Application Number: 10/646,478
Filing Date: August 22, 2003
Appellant(s): KAWAGOE, DAISUKE

EXAMINER'S ANSWER

Appendix "A", marked up figure 6 of Carpenter et al., US Patent No. 6,810,583

Appendix "B", marked up figure 7 of Carpenter et al., US Patent No. 6,810,583

FIG. 6

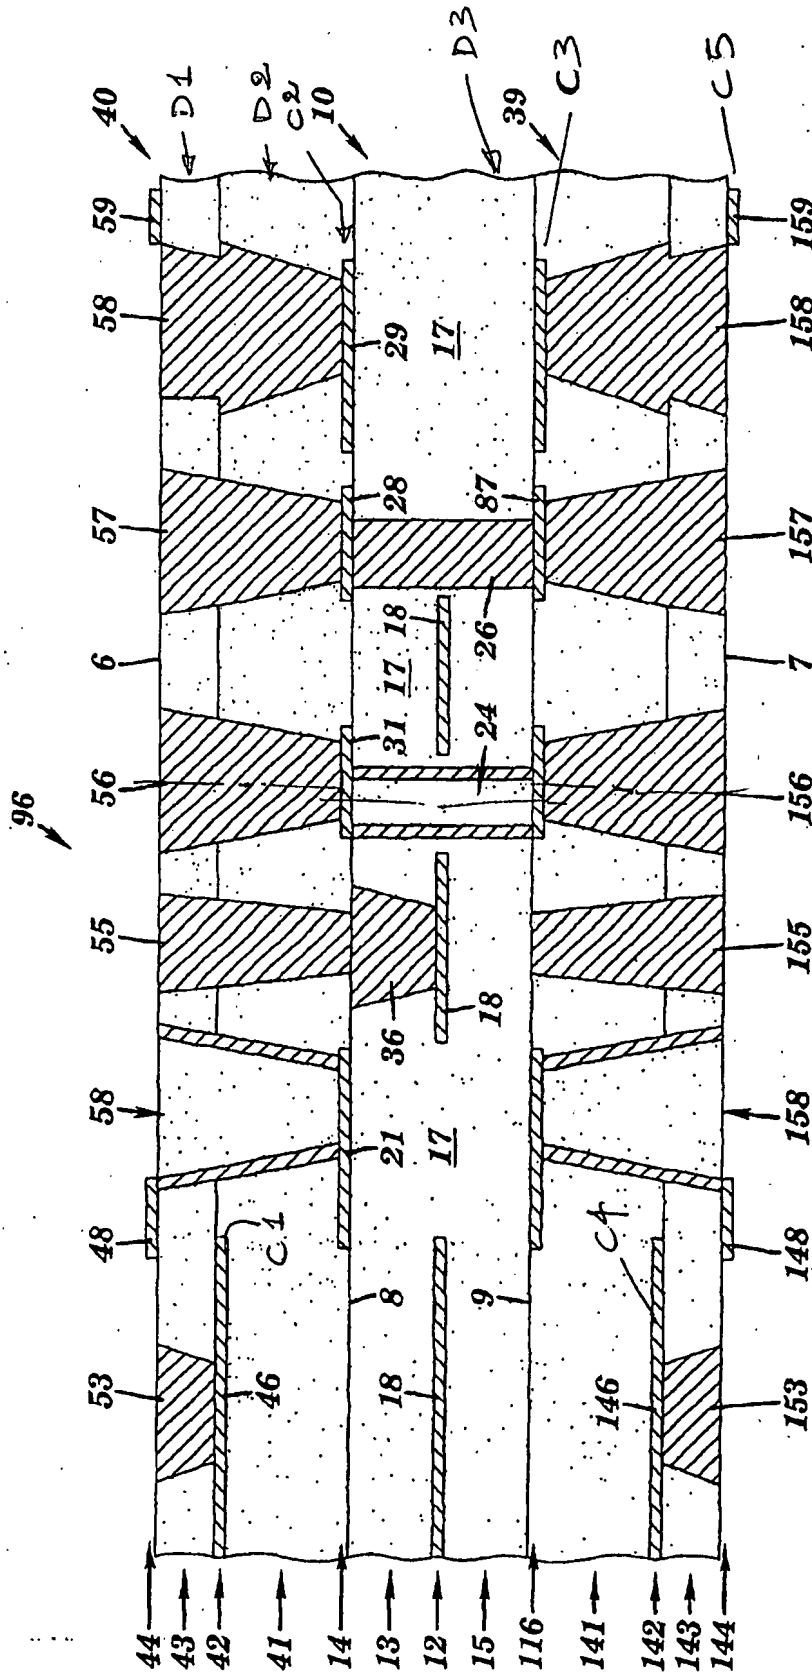
Regarding claim 40, Carpenter, in figure 6, discloses a substrate comprising: a first dielectric layer (D1, as marked up on figure 6 in appendix "A"); a second dielectric layer (D2, as marked up on figure 6 in appendix "A"); a first conductive layer (C1, as marked up on figure 6 in appendix "A"); between the first and second dielectric layers; a third dielectric layer (D3, as marked up on figure 6 in appendix "A"); the second dielectric layer being between the first and third dielectric layers; a second conductive layer (C2, as marked up on figure 6 in appendix "A"); between the second dielectric layer and the third dielectric layer, the second conductive layer including a first skip via (57) that extends through the first and second dielectric layers; and a third conductive layer (C3) on the third dielectric layer, the third conductive layer including a second via (26) that extends through the third dielectric layer, the second via and the first skip via being stacked on top of one another (see marked up figure 6 in appendix "A").

Regarding claim 41, Carpenter further discloses the first skip via includes a longitudinal axis (longitudinal axis passing through the first skip via, see marked up in figure 6, in appendix "A") and the second via includes a longitudinal axis (longitudinal axis passing through the second via, see marked up in figure 6, in appendix "A"), the longitudinal axis of the first skip via being substantially aligned with the longitudinal axis of the second via (see marked up in figure 6, in appendix "A").

Regarding claim 42, Carpenter further discloses the first, second and third dielectric layers are formed on a core (C5, see marked up in figure 6, in appendix "A").

Regarding claim 43, Carpenter further discloses a fourth conductive layer (C4, see marked up in figure 6, in appendix "A") between the first dielectric layer and the core.

Regarding claim 44, Carpenter further discloses the first, second and third conductive layers are patterned conductive layers (see figure 6).

C1, C2, C3, C4, C5, as marked up on the figure is indicating a conductive layer on the surface of the dielectric layer and not only the element pointed by the arrow.

As clearly shown in the marked up figure (6, appendix “A”), via (57) is a skip via passing through first (D1) and second (D2) dielectric layers and in direct contact with the second conductor layer (C2). Therefore, the structure of Carpenter as shown in marked up figure (6) shows **“the second conductive layer (C2) including a first skip via (57) that extend through the first (D1) and second (D2) dielectric layers”** as recited in the claim. This is a structural claim and figure (6) as explained, discloses the final structure as recited in the claim. Different cross hatching pattern identifies the conductor layer and the via, but as a whole discloses the structure as recited in the claim. Therefore, Carpenter et al. meets the limitation.

As clearly shown in the marked up figure (6, appendix “A”), via (26) pass through the dielectric layer (D3) and in direct contact with the conductor layer (C3). Therefore, the structure of Carpenter as shown in marked up figure (6) shows **“the third**

conductive layer (C3) including a second via (26) that extends through the third dielectric layer” as recited in the claim. This is a structural claim and figure (6, marked up), as explained, discloses the final structure as recited in the claim. Different cross hatching pattern identifies the conductor layer and the via, but as a whole discloses the structure as recited in the claim. Therefore, Carpenter et al. meets the limitation.

FIG. 7

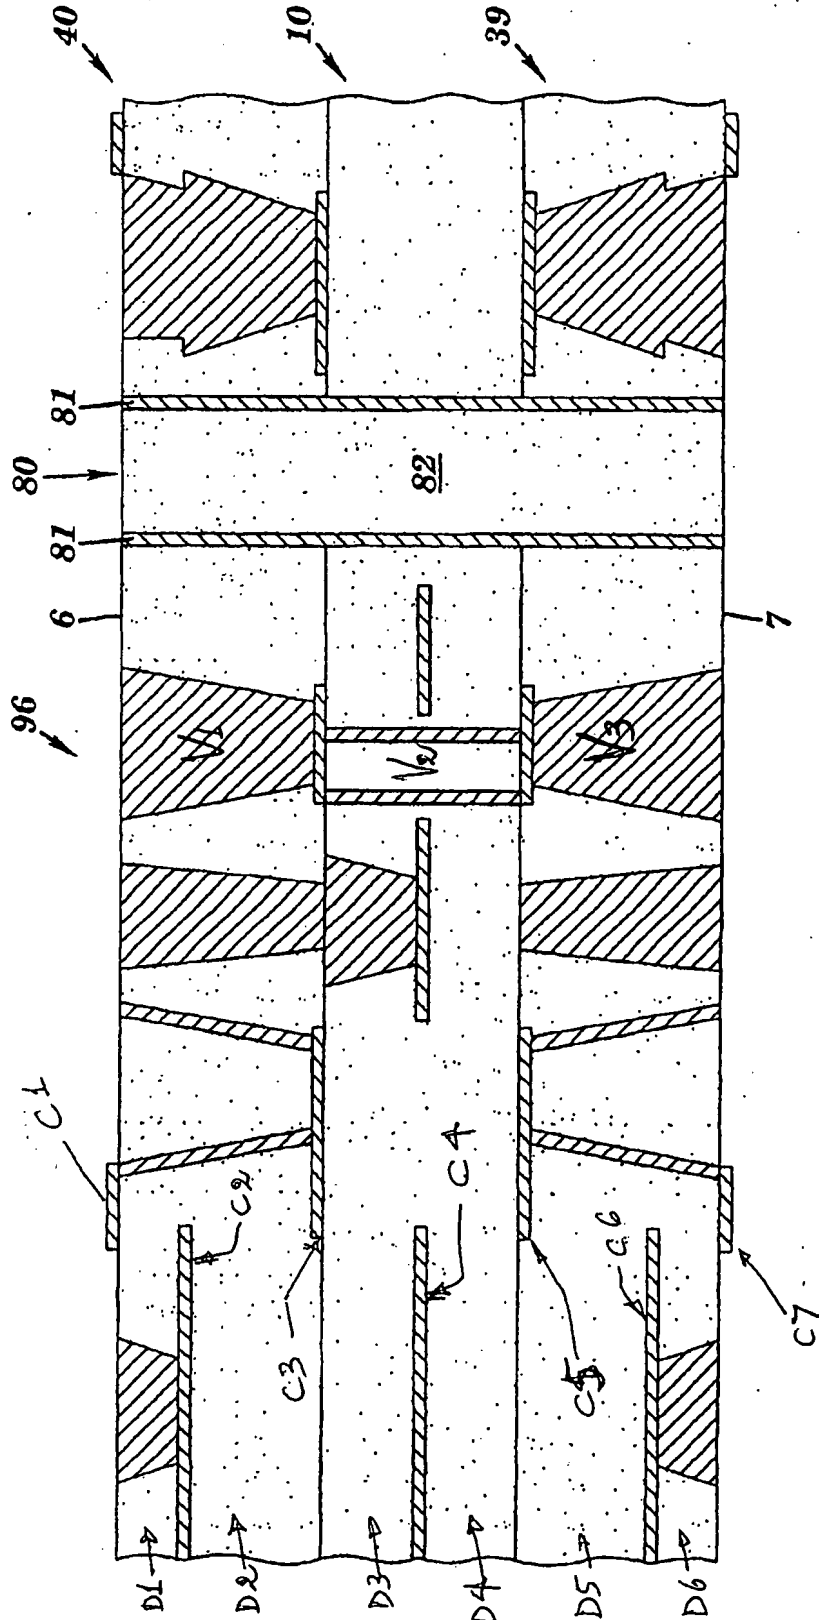
Regarding claim 47, Carpenter, in figure 7, discloses a substrate comprising: a first dielectric layer (D1, marked up on figure 7 in appendix "B"); a second dielectric layer (D2, marked up on figure 7 in appendix "B"); a first conductive layer (C2, marked up on figure 7 in appendix "B") between the first and second dielectric layers; a third dielectric layer (D3, marked up on figure 7 in appendix "B"), the second dielectric layer being between the first and third dielectric layers; a second conductive layer (C3, marked up on figure 7 in appendix "B") between the second and third dielectric layers, the second conductive layer including a first skip via (V1, marked up on figure 7 in appendix "B") that extends through the first and second dielectric layers; a fourth dielectric layer (D4, marked up on figure 7 in appendix "B"), the third dielectric layer being between the second and fourth dielectric layers; a third conductive layer (C4,

marked up on figure 7 in appendix "B") between the third and fourth dielectric layers; and a fourth conductive layer (C5, marked up on figure 7 in appendix "B") on the fourth dielectric layer, the fourth conductive layer including a second skip via (V2, marked up on figure 7 in appendix "B") that extends through the third and fourth dielectric layers, the second skip via and the first skip via being stacked on top of one another (see marked figure 7 in appendix "B").

Regarding claim 48, Carpenter further discloses the first skip via and the second skip via each include a longitudinal axis (longitudinal axis of axis of first skip via and second skip via), the longitudinal axis of the first skip via being substantially aligned with the longitudinal axis of the second skip via (see marked up figure 7 in appendix "B").

Regarding claim 49, Carpenter further discloses the first, second, third and fourth dielectric layers are formed on a core (C7, as marked up on figure 7 in appendix "B").

Regarding claim 50, Carpenter further discloses a fifth conductive layer (C6, marked up on figure 7 in appendix "B") between the first dielectric layer and the core.

Regarding claim 51, Carpenter further discloses the first, second, third and fourth conductive layers are patterned conductive layers (see figure 7).

Regarding claim 54, Carpenter discloses all the features of the claimed invention as applied to claim 47 above, including a fifth dielectric layer (D5, marked up on figure 7 in appendix "B"), the fourth conductive layer (C5, marked on figure 7 in appendix "B") being between the fourth and fifth dielectric layers; a sixth dielectric layer (D6, marked up on figure 7 in appendix "B"), the fifth dielectric layer being between the fourth and sixth dielectric layers; a fifth conductive layer (C6, marked up on figure 7 in appendix "B") between the fifth and sixth dielectric layers; a sixth conductive layer (C7, marked up on figure 7 in appendix "B") on the sixth dielectric layer. Carpenter further discloses a third sip via (V3, marked up on figure 7 in appendix "B"), a third skip via that extends through the fifth and sixth dielectric layers, but does not disclose the sixth conductive layer including connected to the third skip via. However, as can be seen at various places in the figure, the conductor layer / patterns are connected to the via

Regarding claim 55, Carpenter further discloses the first, second and third skip vias each include a longitudinal axis, the longitudinal axis of the first skip via being substantially aligned with the longitudinal axis of the second and third skip vias (see marked up figure 7 in appendix "B").

C1, C2, C3, C4, C5, C6, C7, as marked up on the figure is indicating a conductive layer on the surface of the dielectric layer and not only the element pointed by the arrow.

As clearly shown in the marked up figure (7, appendix “B”) the first skip via (V1) extend through the first (D1) and second (D2) dielectric layers and is in direct contact with the second conductive layer (C3). This is a structural claim and the figure (7, marked up), as explained, discloses the final structure as recited in the claim. Therefore, Carpenter discloses, **“the second conductive layer (C3) including a first skip via (V1) that extends through the first (D1) and second (D2) dielectric layers”**.

As clearly shown in the marked figure (7, appendix “B”) the second skip via (V2) extends through the third (D3) and fourth (D4) dielectric layers and in direct contact with the fourth conductive layer (C5). This is a structural claim and the figure (7, marked up), as explained, discloses the final structure as recited in the claim. Therefore, Carpenter discloses **“the fourth conductive layer (C5) including a second skip via (V2) that extends through the third (D3) and fourth (D4) dielectric layers”** as recited in the claim. Different cross hatching pattern identifies the conductor layer and the via, but as a whole discloses the structure as recited in the claim. Therefore, Carpenter et al. meets the limitation.
